Design Review Commission Report

Meeting Date: Thursday, July 7, 2016

Subject: **527 North Palm Drive (PL1608828)**

A request for an R-1 Design Review Permit to allow the construction of a new two-story single-family residence located in the Central Area of the City north of Santa Monica Boulevard. The Commission will also consider adoption of a Categorical Exemption, pursuant to the California Environmental Quality Act.

AS 100
SITE PLAN

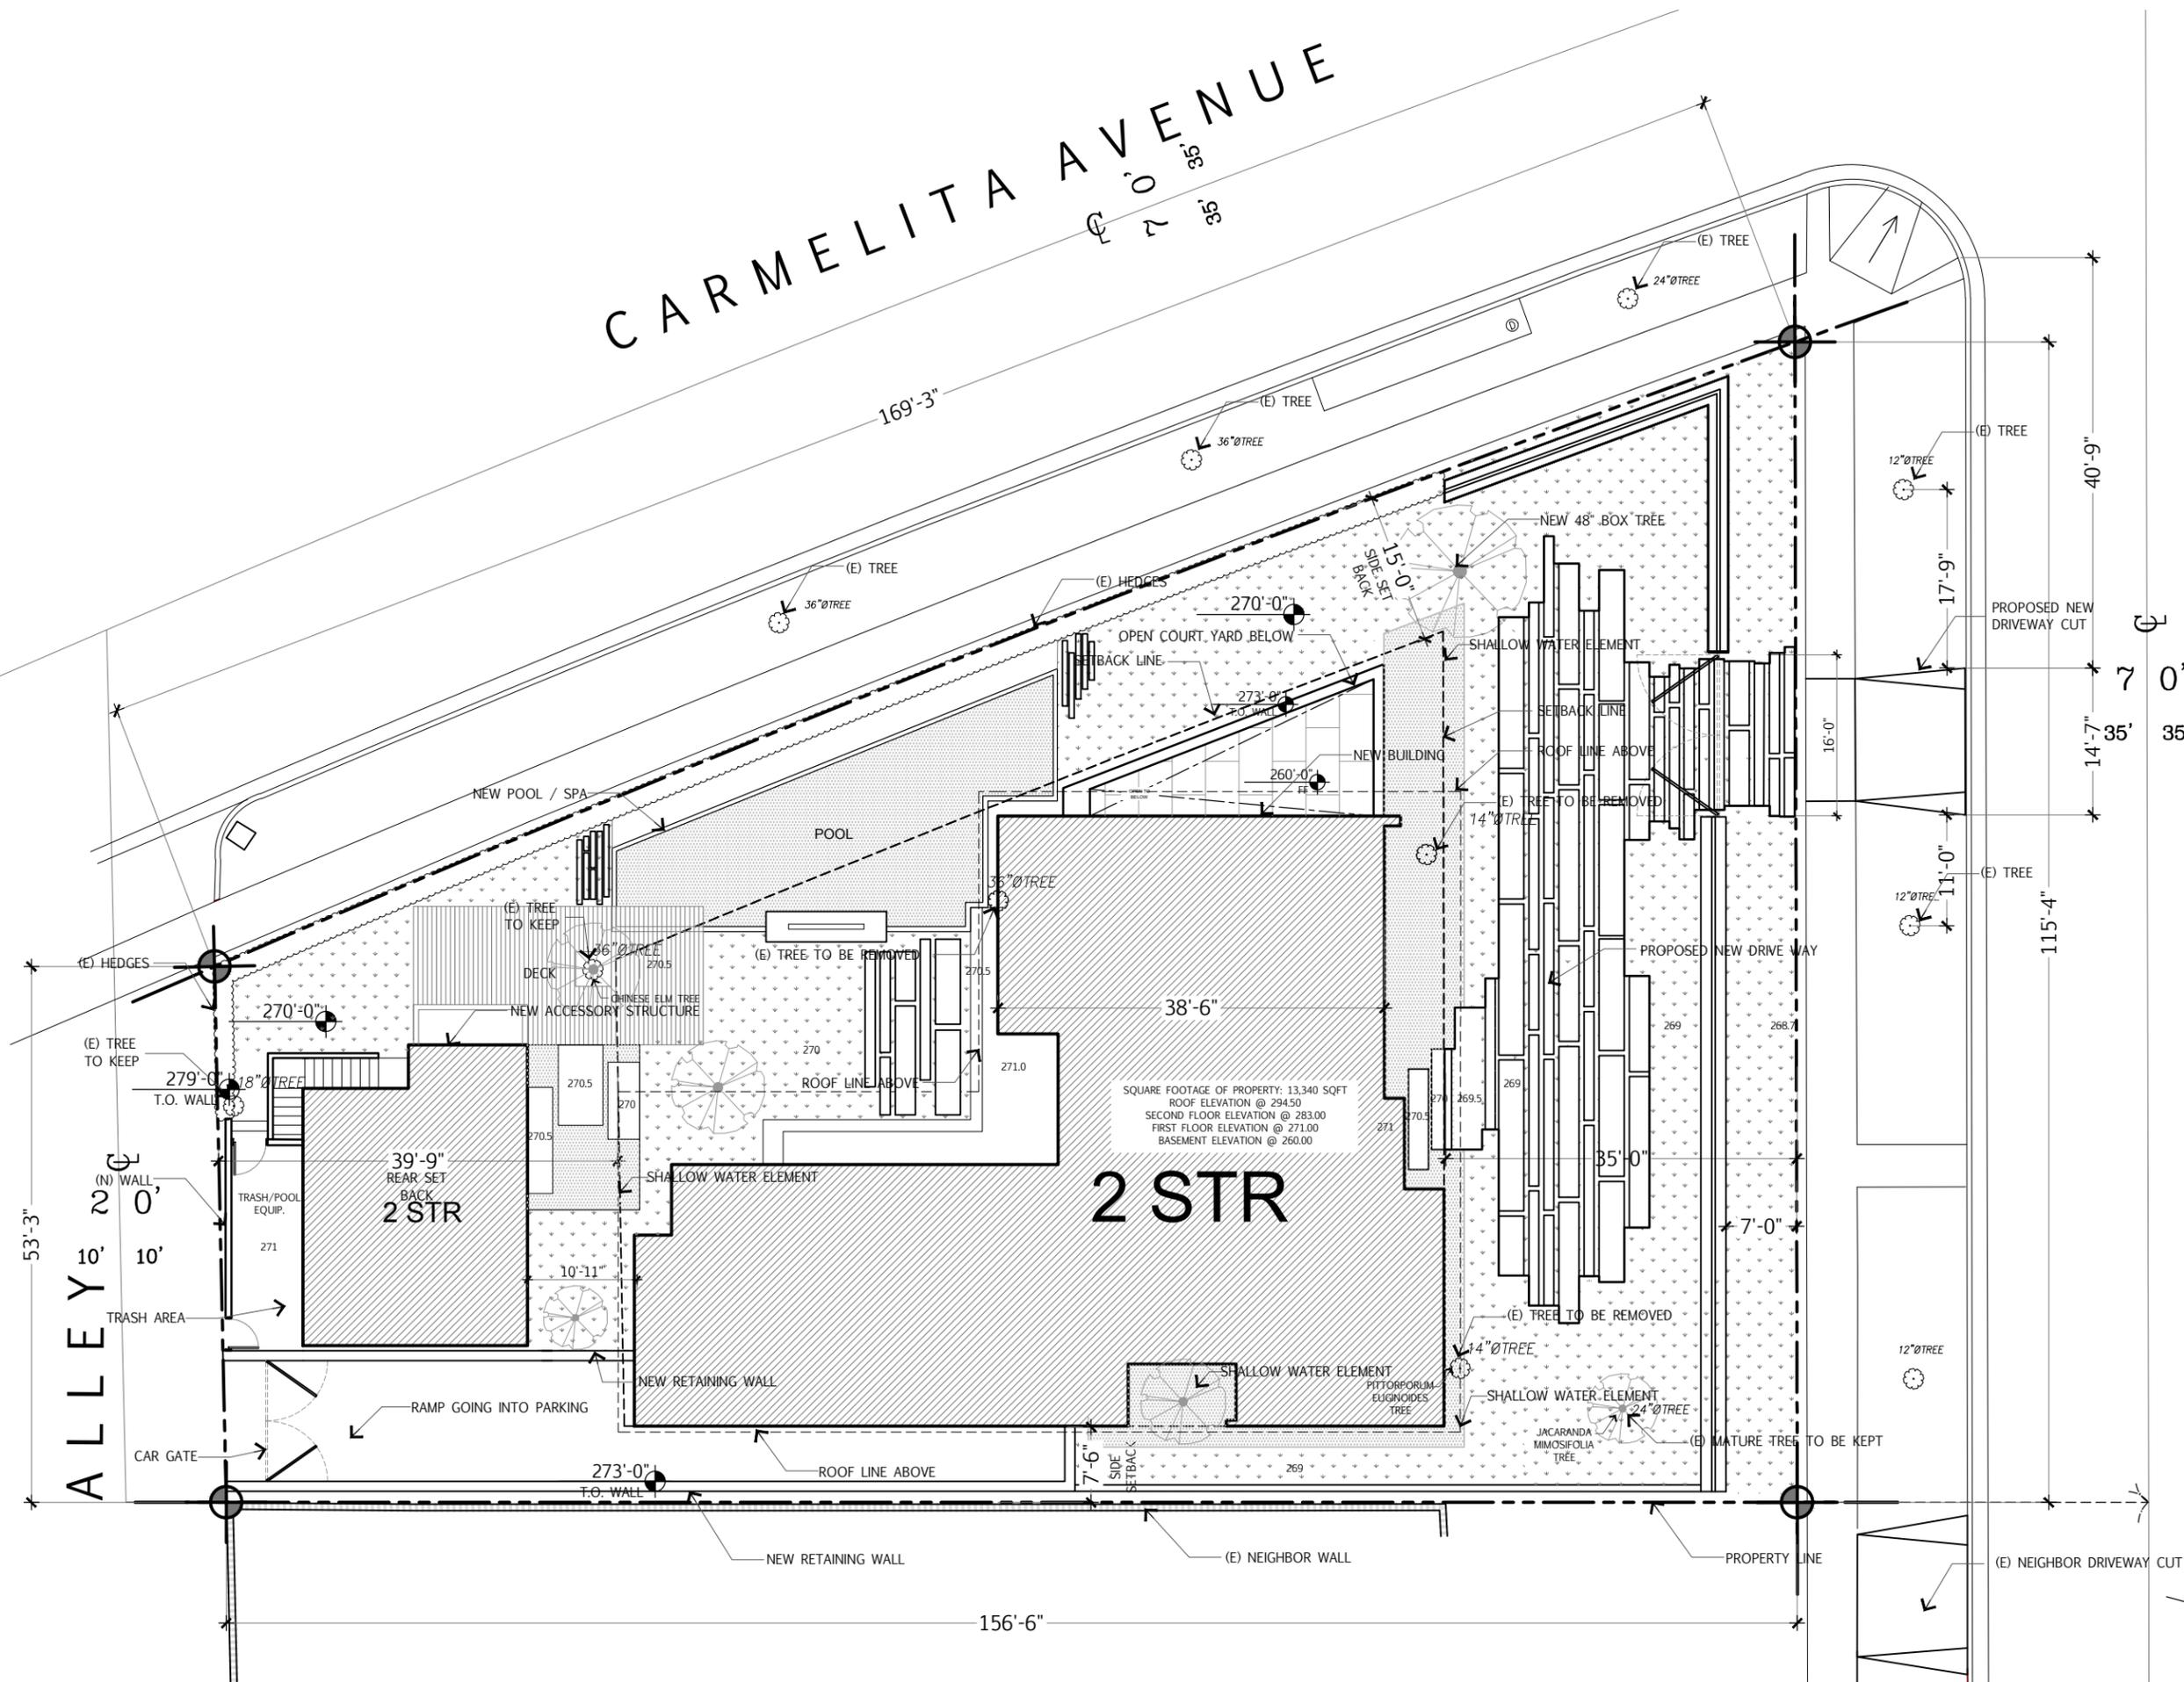
- Study the manner in which the building addresses the northeast corner of the site, as the residence is located on a prominent corner lot and steps back significantly from the street edge to accommodate a large light well at the front building corner, and driveway access. The residence also steps back significantly along Carmelita Avenue to accommodate a proposed swimming pool. Architectural studies should be undertaken that allow the structure to better engage the street edge and respond appropriately to the public realm.
- Further review the new curb cut proposed on North Palm Drive and the associated parking provided in the front setback and consider alternate, less prominent, locations for automobile access and surface parking.

- Study the “permeability” of any proposed site walls and proposed automobile access gate(s) on the street-facing elevations to create more openness and to generate a pedestrian friendly face to the street. In addition, the proposed front yard wall and fence does not appear to meet the code requirements for “open to public view” for the portion over three feet in height.

1 EXTERIOR ELEVATION - EAST

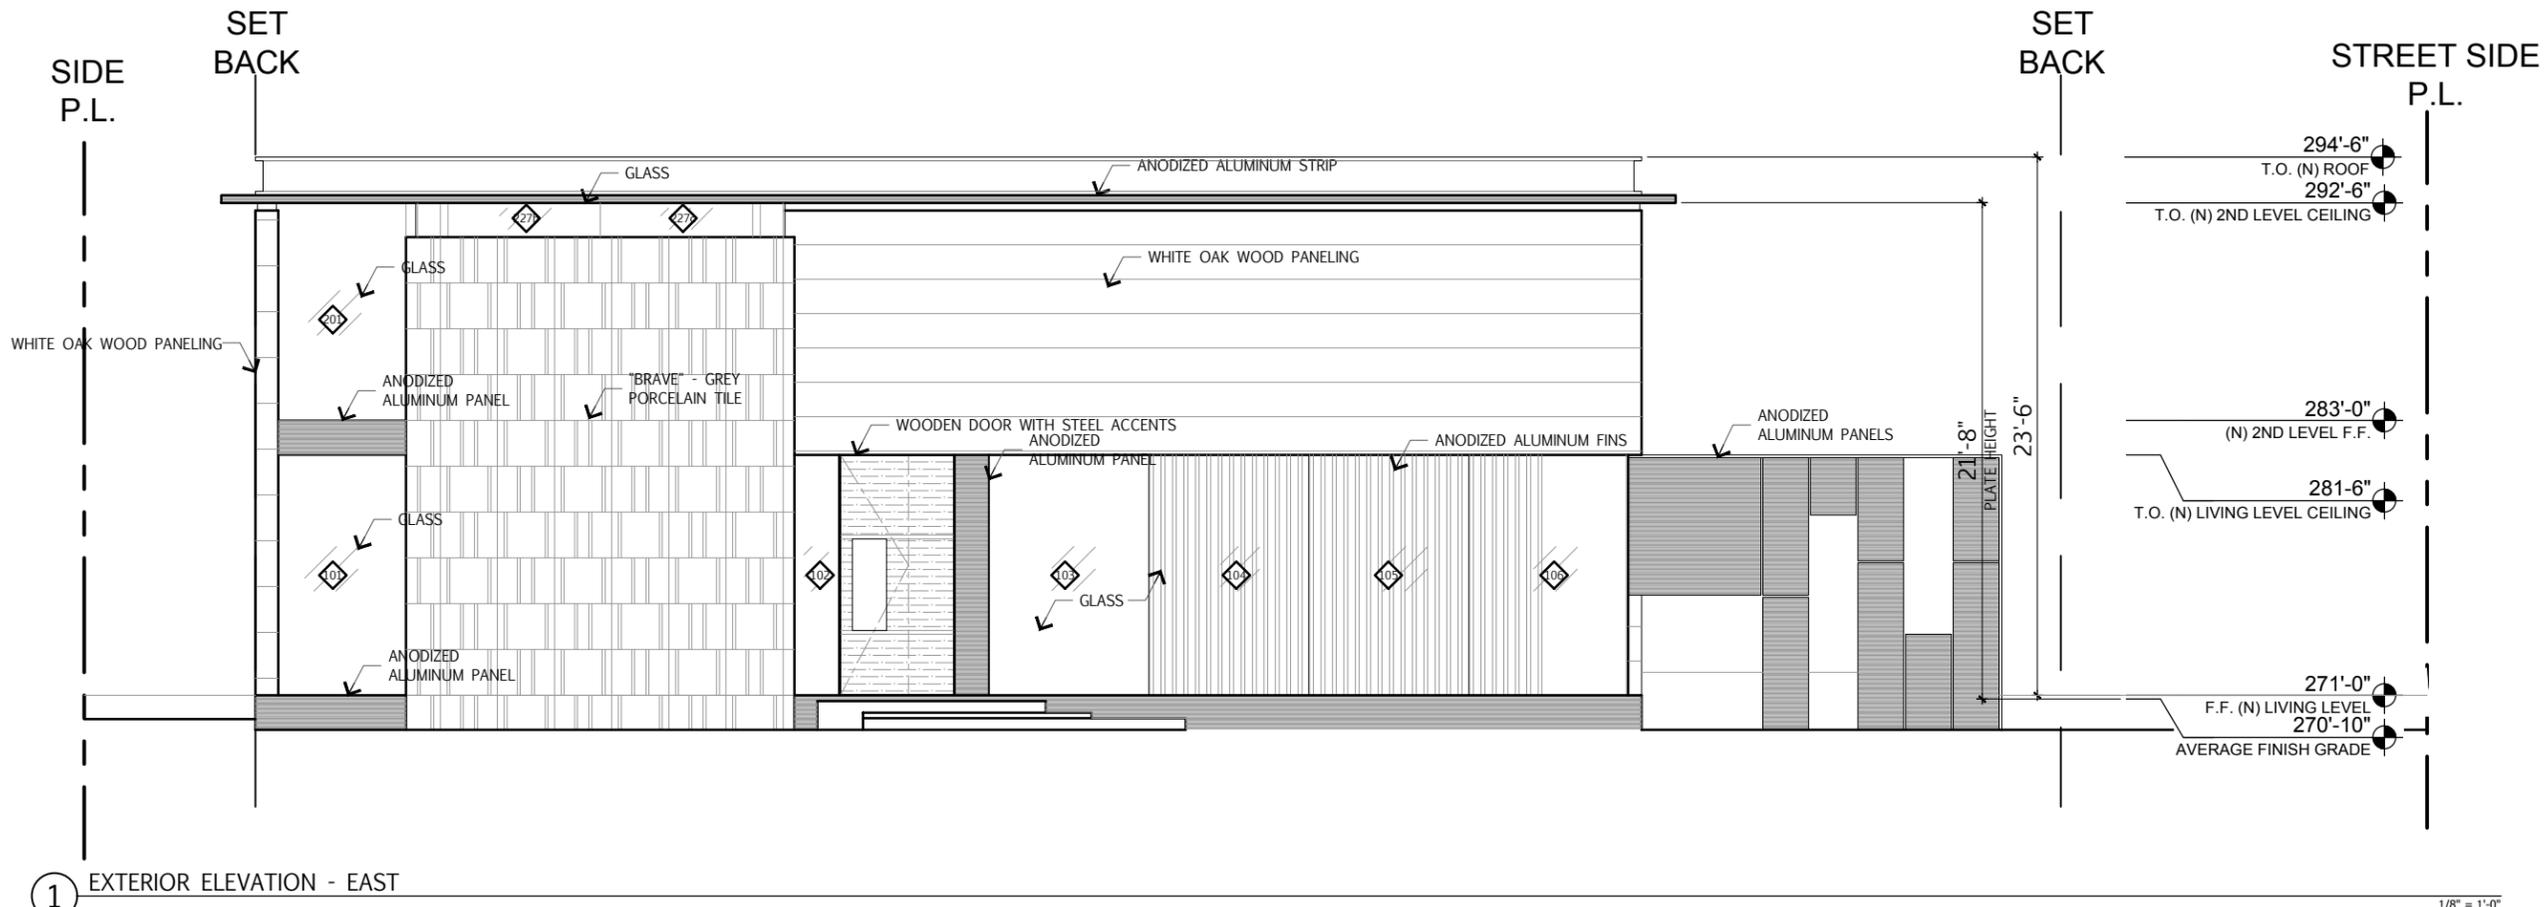
- Review the interior programming of the residence in conjunction with the location of the bathrooms on the first and second floors which abut the east (street-facing) building wall. A study of this building elevation in conjunction with the minor relocation of the bathrooms on both floors would allow for the introduction of additional glazing on the front elevation and create a less imposing façade at the street edge.

- Provide specifications for the external building corners for the materials proposed to ensure that an appropriate architectural detail is including in the final building plan set. In addition, provide a detail for a more generous recess for all glazing proposed on the street-facing elevations.
